MOOLARBEN COAL PROJECT GROUNDWATER ASSESSMENT

RESPONSE TO CONCERNS RAISED BY INDEPENDENT HEARING AND ASSESSMENT PANEL (IHAP)

14 DECEMBER 2006

05-0158-R03C

Figure 1: Predicted groundwater inflows to Moolarben underground mine

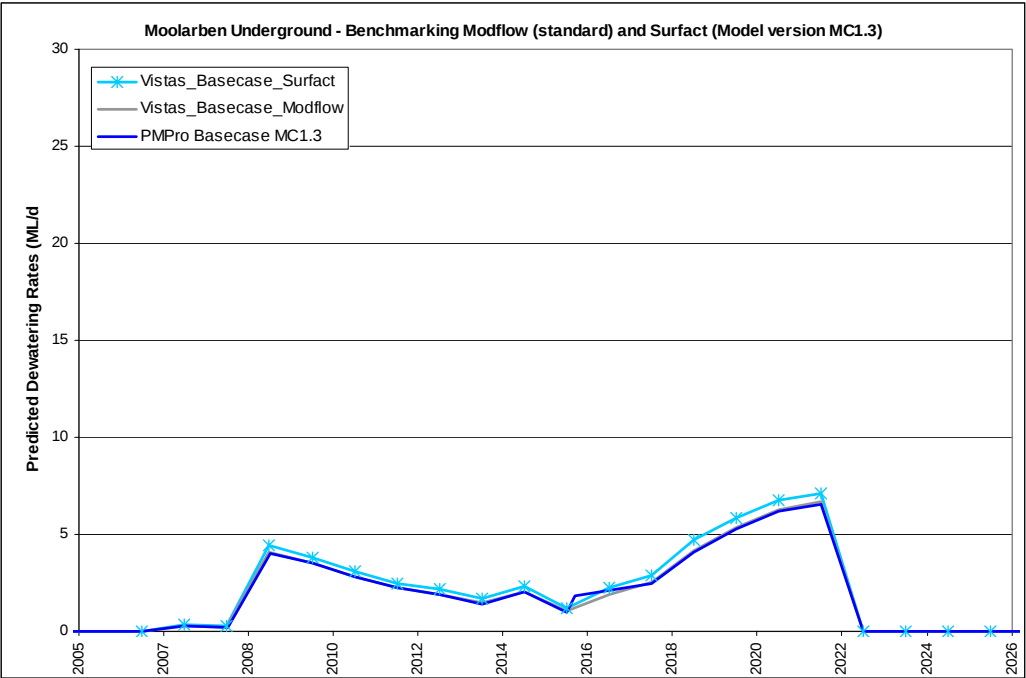
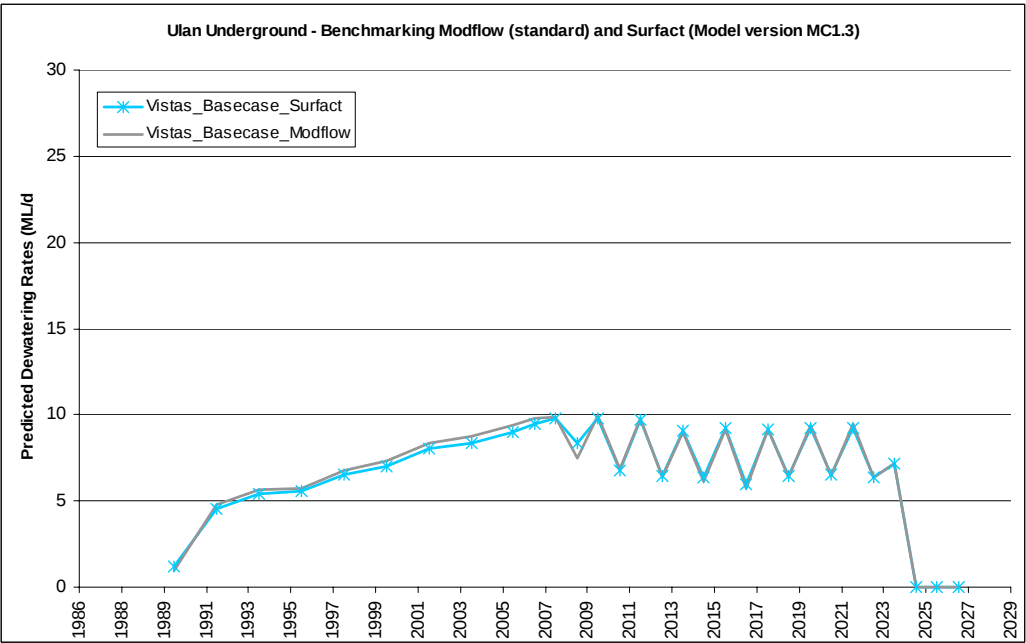
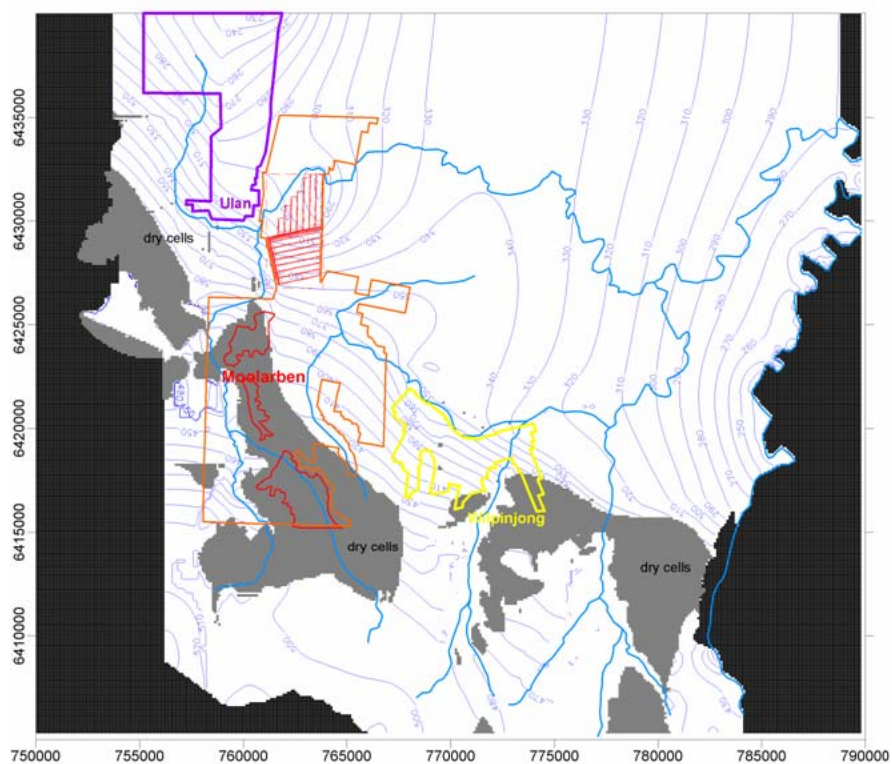
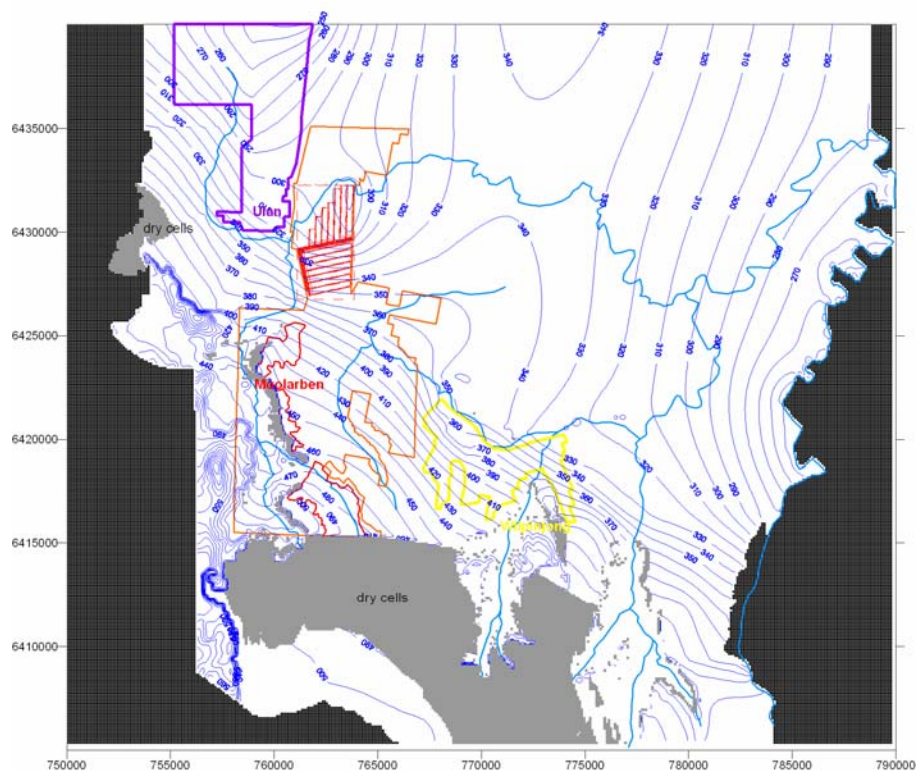
“The groundwater numerical model is based on the Modflow code. Appendix F of the report states that Modflow is a suitable code for this study (ie for simulating open cut development and underground mining). Can it be assumed that processes like pit seepage faces, steep hydraulic gradients and underground panel extractions (where a failure regime is propagated upwards), are simulated with sufficient accuracy to confidently assess impacts on the groundwater systems in space and time? Would an alternative code offer an improved level of accuracy in predicting pressure distributions and fluxes?”

Subsequent to the release of the EA report, we have re-run the model using Surfact, which does have the capability to simulate unsaturated cells, and achieved an almost identical output to the reported base case impacts, confirming that Modflow was an appropriate software in respect of the dry cell problem. **Figures 1 and 2** show the progressive inflow rates predicted to occur to the Moolarben and Ulan underground mines derived from straight Modflow model runs using both the PMPro and Vistas interface software, and from a run with Surfact.

As well as mine inflows, the three model runs generated almost identical groundwater level distributions. The head distributions for the Ulan Seam (model Layer 4) for the PMPro Modflow and Surfact runs are presented for comparison in **Figures 3 and 4**.

Figure 5: Predicted groundwater inflow rates at Moolarben Underground 4 (drains de-activated and drains left on)

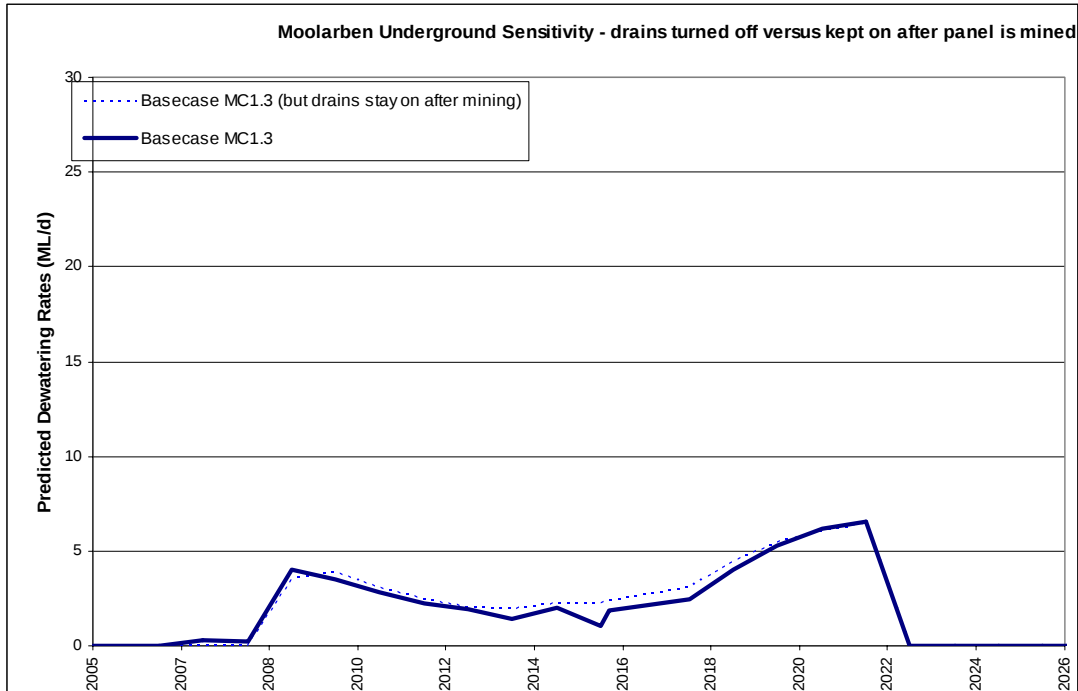
“Simulation of longwall panels and goaf should provide for sustained drainage of groundwaters rather than the methodology employed to date of switching panel (model) drains off after extraction. Mining operations generally do not allow a build up of water in goafed areas up dip of operations or in any intended development area (safety issues).”

Response: The approach of activating and de-activating drain cells is described in detail in Section 3.3 of Aquaterra (2006), and applies to both Ulan and Moolarben underground areas, and was implemented in this manner as a reasonable approach to represent the mining process. Although the drain cells were de-activated in the goaf areas after extraction, they were kept active in the main development headings. It is accepted that it would have been preferable to leave the drains on, however subsequent modelling showed that the adopted practice of de-activating the drains did not materially alter the predicted inflows or heads.

Figure 5 shows a comparative plot of inflows from two runs, one with goaf drain cells de-activated after extraction, and the other with all drain cells left on. The inflow rates are seen to be only marginally different. It is likely that the minimal difference between the two model runs arises because the development heading drain cells were left activated through the simulation, and were apparently sufficient to keep the mined out areas effectively dewatered.

Response: Refer **Section 2.9** and **Figure 5** above.
